PERROW PARK – ADDENDUM #1 SUMMARY

Project Name: Perrow Park
GMC Project Number: LATL240013
Addendum Date: June 12, 2025

Index and Summary of Changes:

C-300

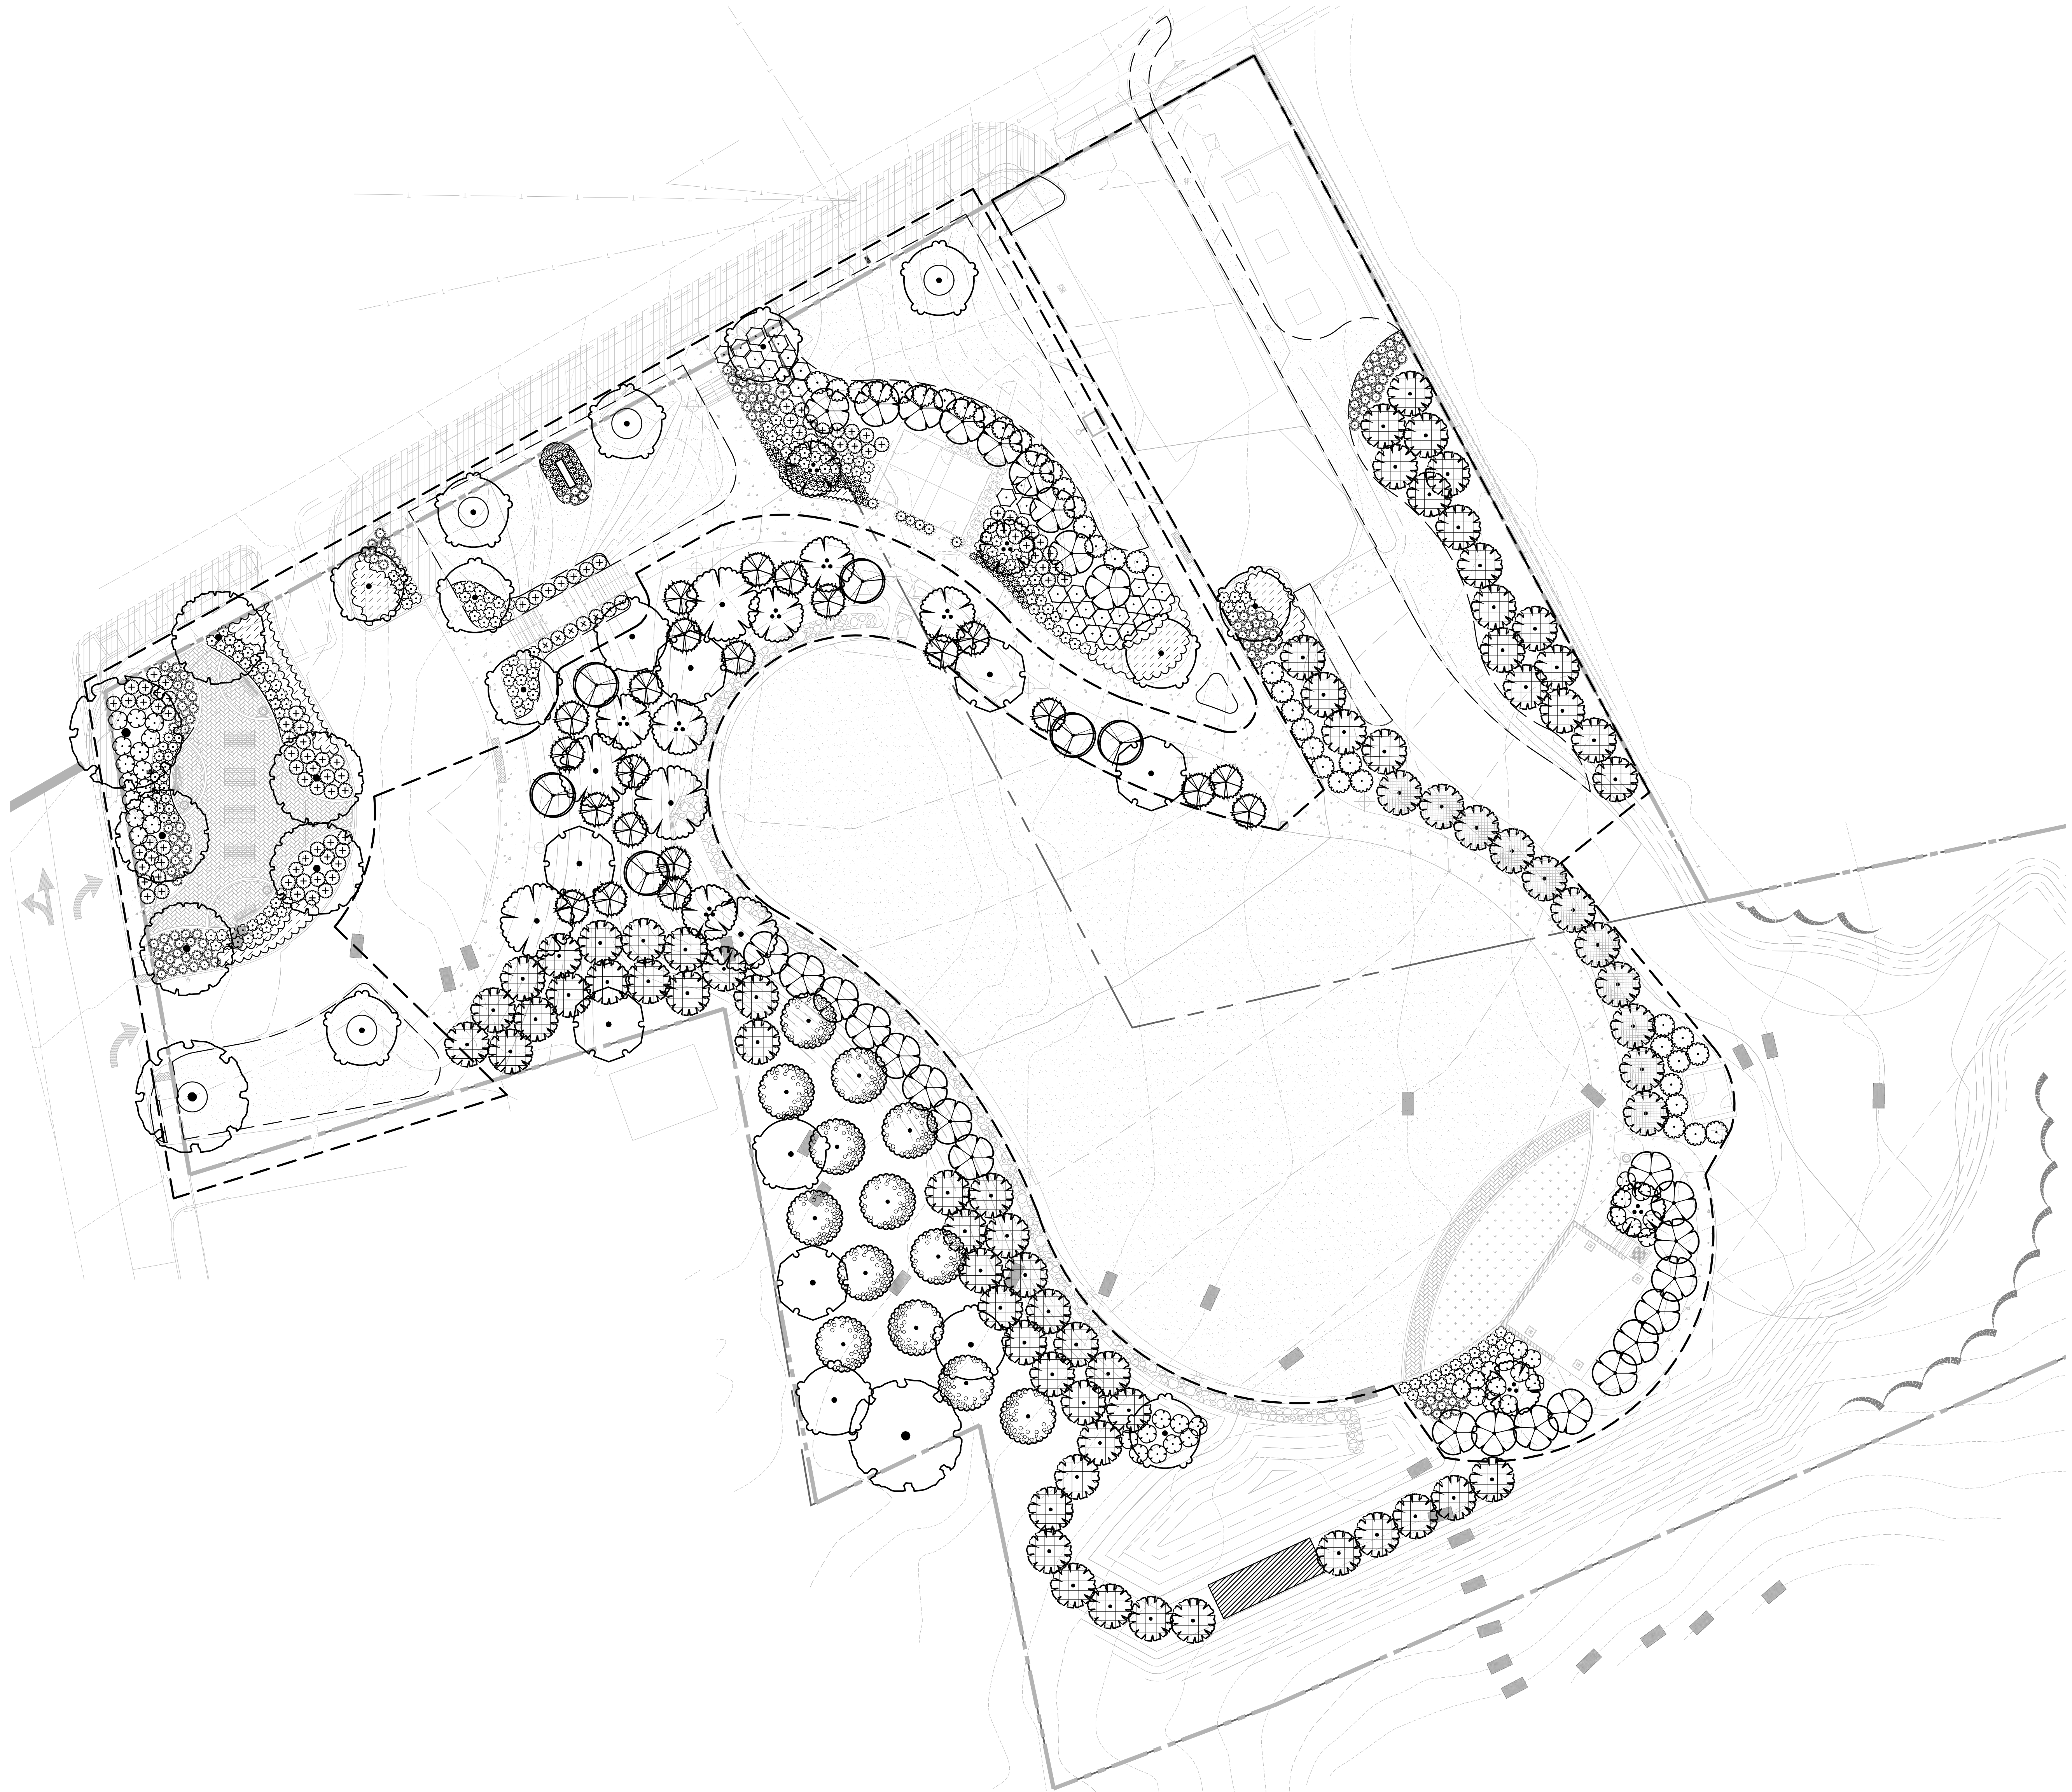
- **Pre-Bid Sign-In Sheet**
- **Bid Questions and Responses**
- **C-003**
 - o Existing shrubs along South Main Street shown as removed by City of Jasper
 - o Existing concrete and asphalt drives along East Spring Street shown as being removed by City of Jasper
- **C-100**
 - o Yield Sign at first entrance on East Spring Street called out
 - o Stop bar, stop sign, and double yellow striping added per GDOT
 - o Sight distance certification added per GDOT
- **C-300**
 - o Septic field layout modified
- **L1.01**
 - o Correct label reference to lighted bollard along southwest edge of event lawn
- **L3.02**
 - o New sheet to include the extents of design-build irrigation areas
